CITY OF KELOWNA
MEMORANDUM

Date: October 18, 2006
File No.: OCP06-0019/Z06-0050
To: City Manager
From: Planning & Development Services Department

APPLICATION NO.	OCP06-0019 Z06-0050	APPLICANT:	Neil Denby Runnalls Denby & Associates
AT:	2750 Shayler Court 2880 Shayler Court 2930 Shayler Court 3025 Shayler Court 3099 Shayler Court 3135 Shayler Court 3185 Shayler Court 3215 Shayler Court 3255 Shayler Court	OWNERS:	Steven & Bonnie Cloutier Erwin Braun/Ercon Holdings Ltd. Dave & Moyra Skoglund Leslie Gardner/Klista Redfield Ralph & Tanis Rubini Clark Smith Shane Ginter/Shirley A. Ginter Bob Gruber/616507 B.C. Ltd. Clark Smith/616507 B.C. Ltd.

PURPOSE: To amend the Official Community Plan Future Land Use designation from Future Urban Reserve to Rural/Agricultural and to rezone the subject property from the A1 – Agriculture 1 zone to the RR1 – Rural Residential 1 zone to allow a subdivision to create additional rural residential single family lots.

PROPOSED REZONING/SUBDIVISION SITE PLAN

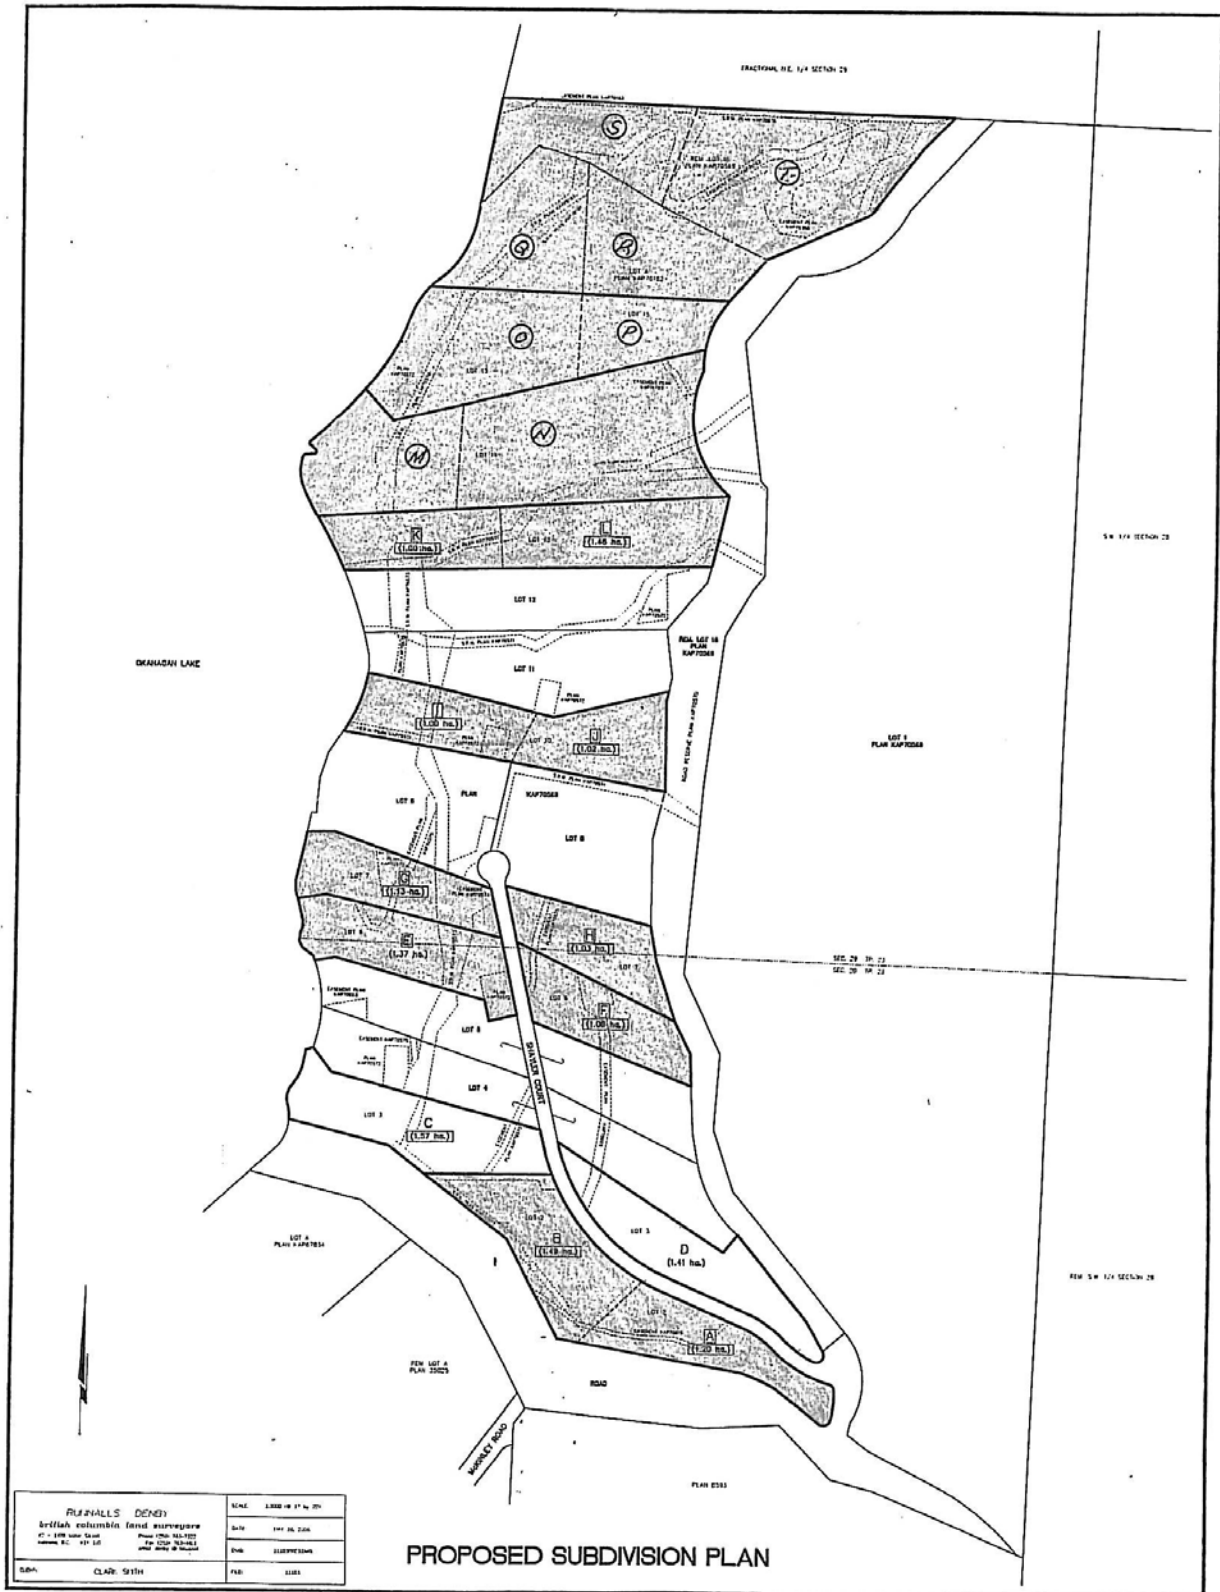
The applicant has provided a preliminary plan of subdivision, for reference with this OCP/Zone amendment request, which is based on the RR1 – Rural Residential 1 zone. The subject properties will ultimately contain one single family dwelling on each property.

The proposed application meets the requirements of the RR1 – Rural Residential 1 Zone, in terms of lot area, width and depth.

The applicant has submitted a plan of proposed subdivision based on the RR1 – Rural Residential zone. The purpose of the RR1 zone is to provide a zone for country residential development, and complementary uses, on larger lots in areas of high natural amenity and limited urban services.

TOPOGRAPHICAL COMPARISON PLAN

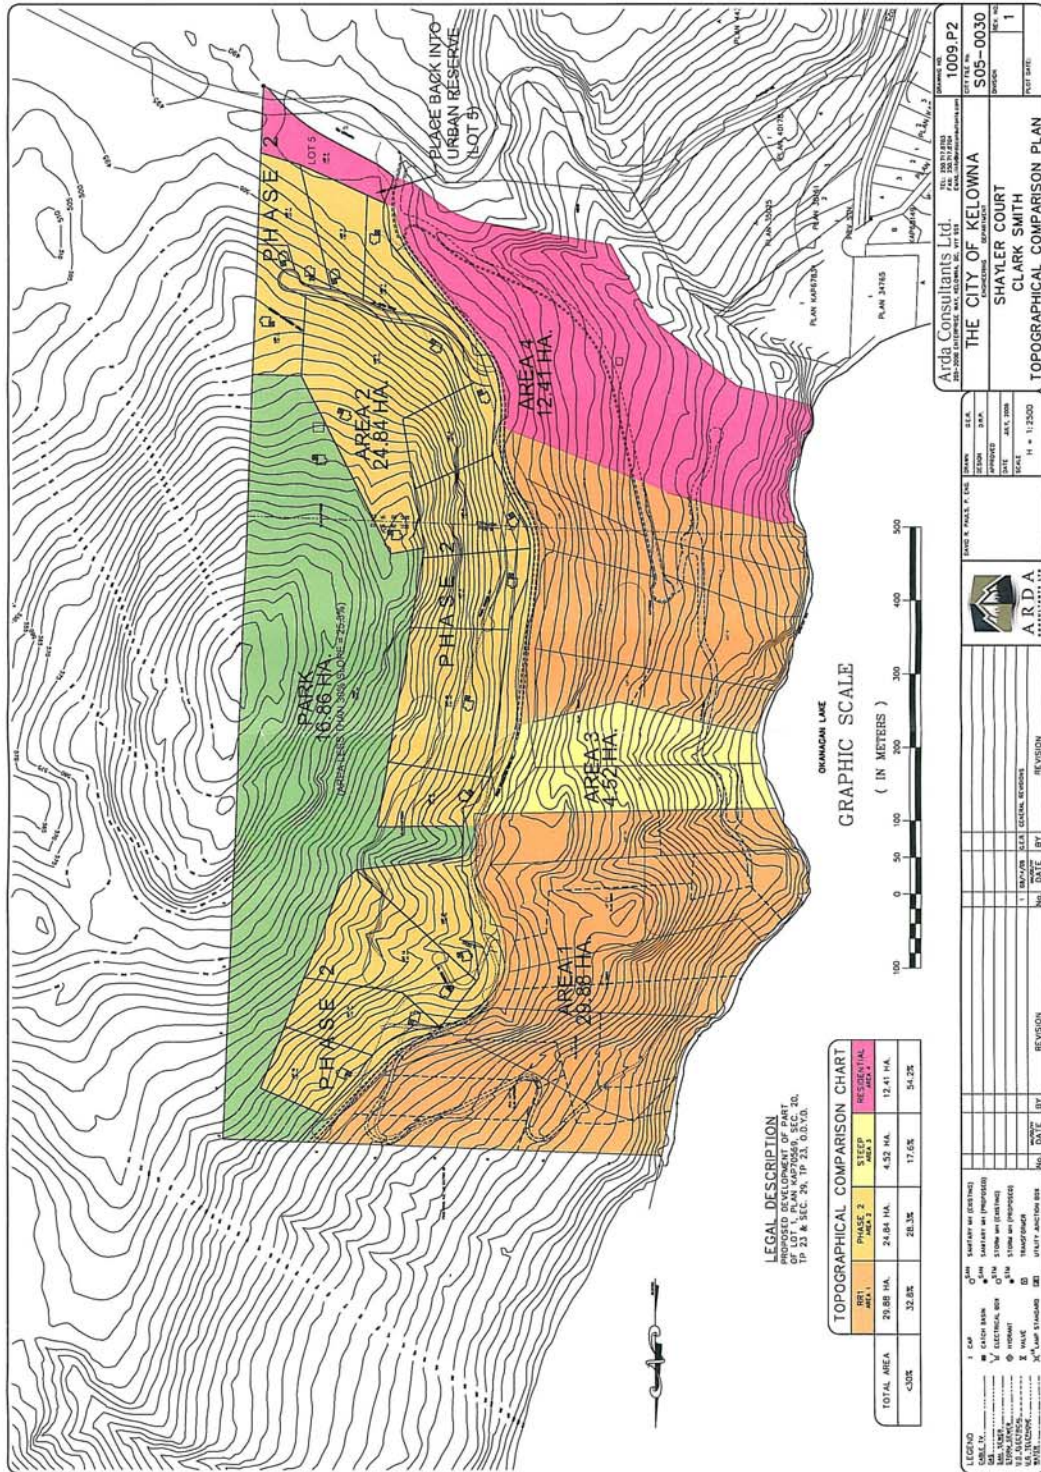
A very high percentage of the lands have slopes well over 30% (see the attached topographical comparison and slope analysis maps) and as such are not conducive for urban types of development. The OCP discourages development on lands with a slope over 30%. Given the topographic conditions of the site, urban densities would generally not be possible other than at the southern most portion of the property.
